COMANCHE PEAK STEAM ELECTRIC STATION - PLAN FOR INSPECTION OF FILES -

TEXAS UTILITIES GENERATING COMPANY
AUDIT REPORT

Subject: Audit of Texas Utilities Generating Company, Dallas Offices
and Comanche Peak Steam Electric Station Construction Site

TUGCO AUDIT
OBSERVATIONS AND RECOMMENDATIONS

EXHIBIT 1

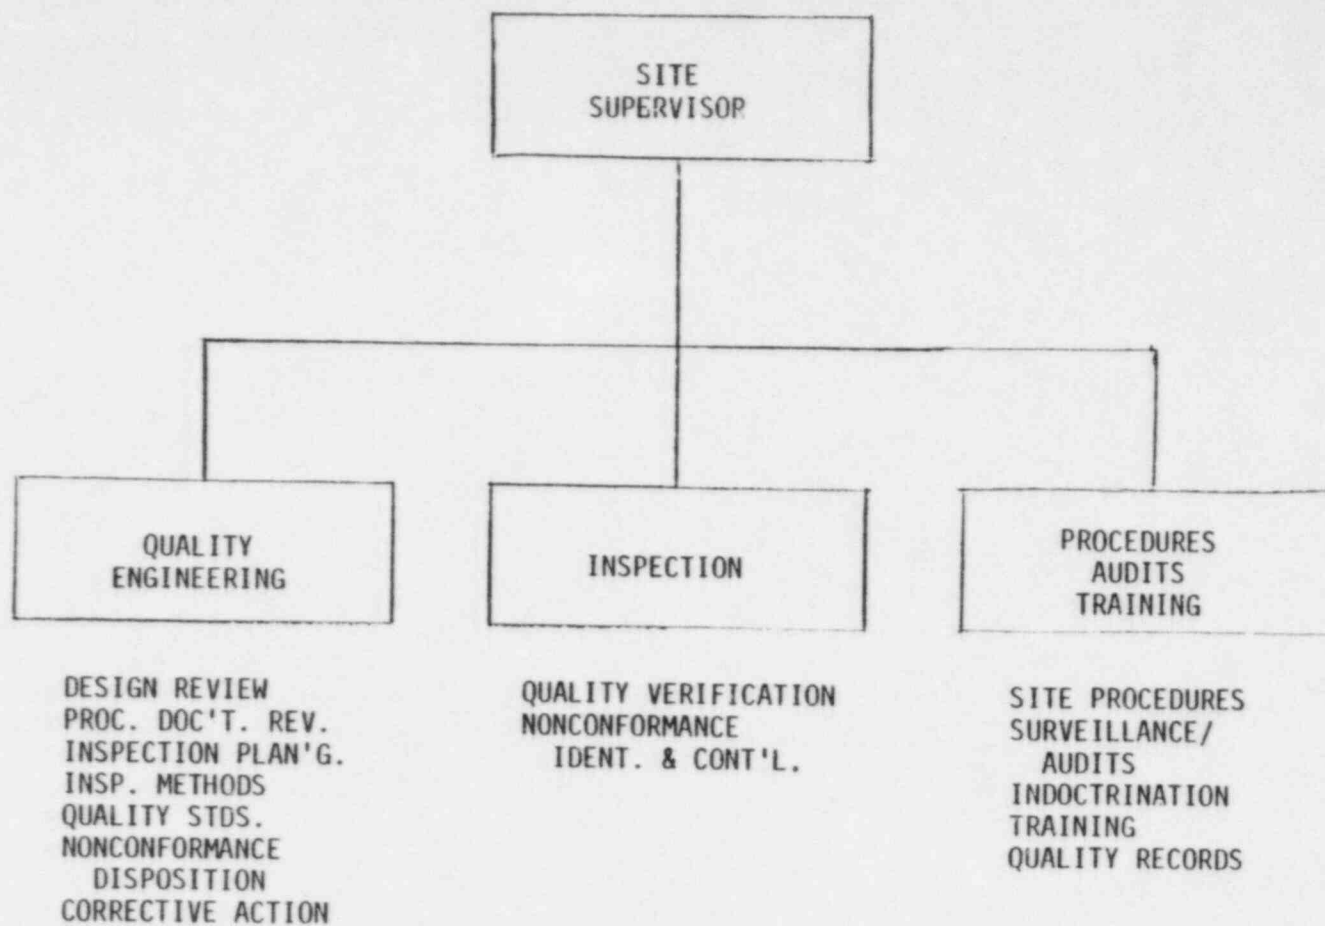
It is recommended that TUGCO adopt an organizational realignment of activities as set forth in Exhibit 1, whereby Quality Engineering and Inspection report to the Site QA Supervisor as two separate sub-organizational entities with responsibilities as defined in Exhibit 1. Such an organization will better supplement the existing Construction organization and will permit better organization for handling day-to-day site problems as well as implementing recommendations of this report. This is particularly so in the area of inspection planning.
